DESIGN CHANGES

Drawing status FOR COMMENT

Project Name County Flats, Sandfields
Project Ref OAD_5174
Drawing Ref 1201
Drawing Name Flat Type B01
Drawn By WS
Date 13.04.2021

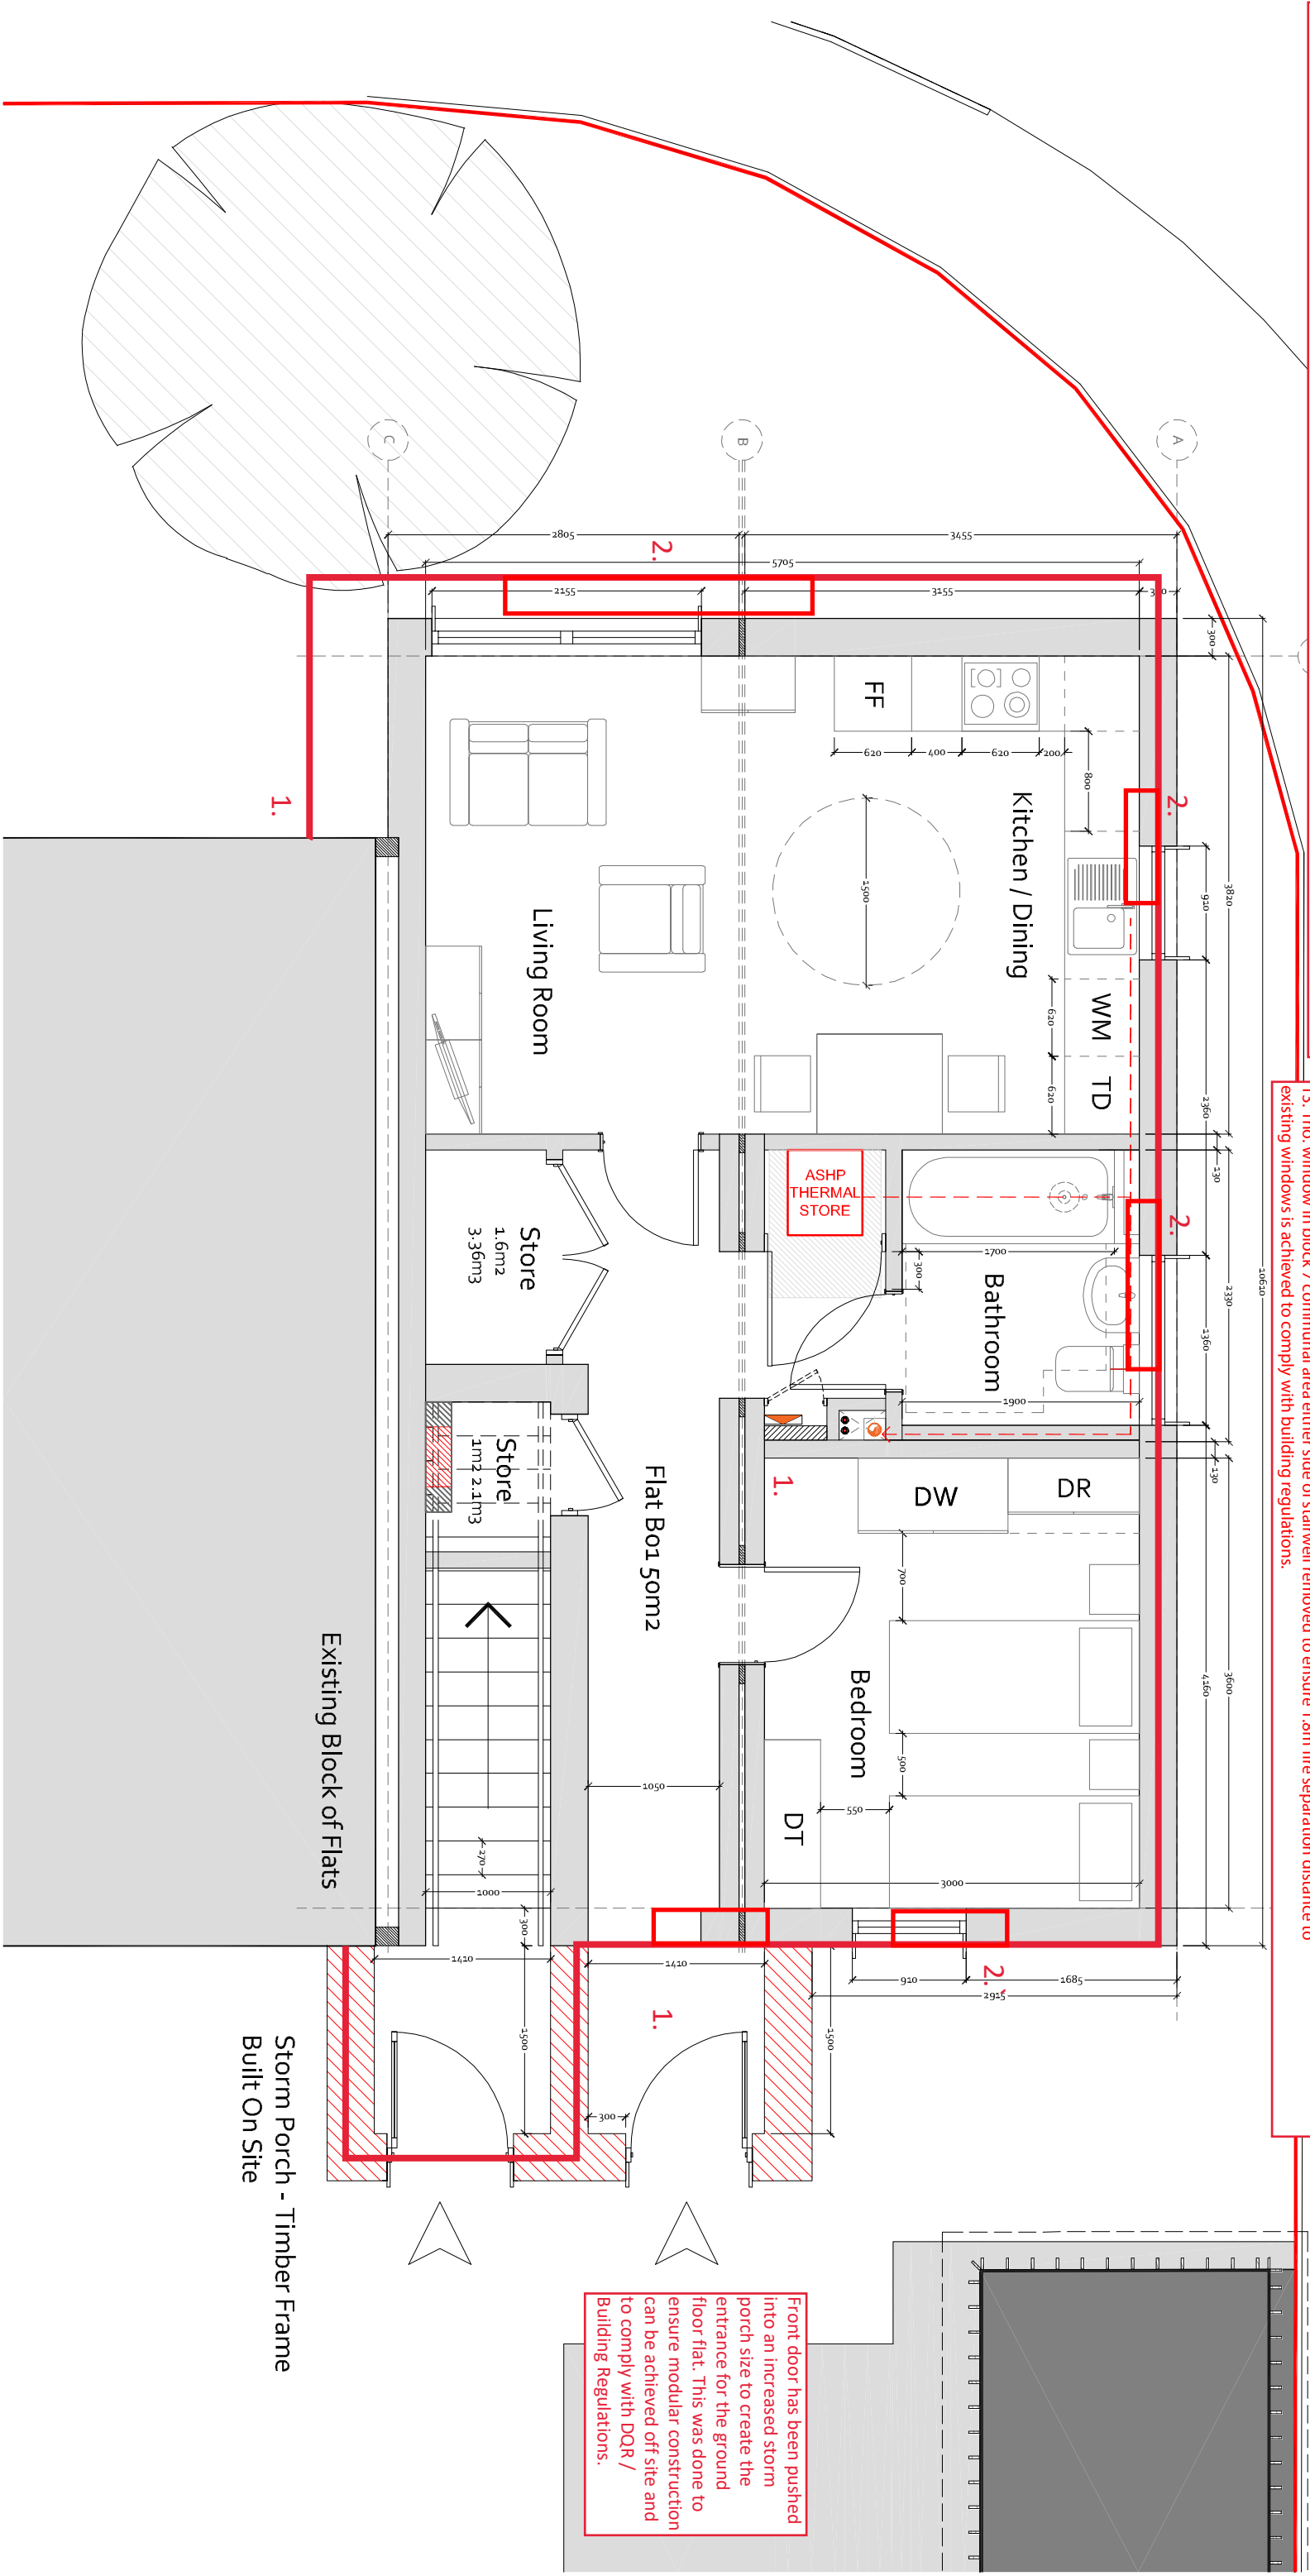
- 1. Modular end links re-positioned slightly off existing buildings, with the party wall straightened and porch projections aligned with this wall, to ensure modular construction can be achieved off site.
- 2. Windows have been slightly re-positioned to the new build to suit the structural design of the modular units and the constraints of the timber frame.
- 3. Parapet to modular end blocks have been lowered by approx 900mm to comply with the structural wind loadings and timber frame design.
- 4. Corner windows have been removed and replaced with 2no. Windows on either corner, again due to the structural and timber frame design of the blocks.
- 5. PV panels have been omitted from the end modular units to suit the structural and timber frame design of the blocks.

- 6. Ground floor Juliet balcony added to existing flats to provide better security whilst ensuring the open areas remain as communal spaces.
- 7. Air source heat pump external louvre enclosure amended to be single storey over entrance canopy to end link blocks.

- 8. External air source lowered enclosure handed to provide internal riser/access requirements for maintenance.
- 9. Buggy/cycle store added to block 6 and 7 parking courtyards.

- 10. Bin stores slightly re-positioned to suit existing drainage runs, with bin store near block 6 amended in size to suit located of bedroom window.
- 11. Footpaths amended to be Tarmac.

- 12. Windows in communal area to the linked blocks made narrower to ensure 1.8m fire separation distance to existing windows is achieved to comply with building regulations.

- 13. 1no. window in block 7 communal area either side of stairwell removed to ensure 1.8m fire separation distance to existing windows is achieved to comply with building regulations.
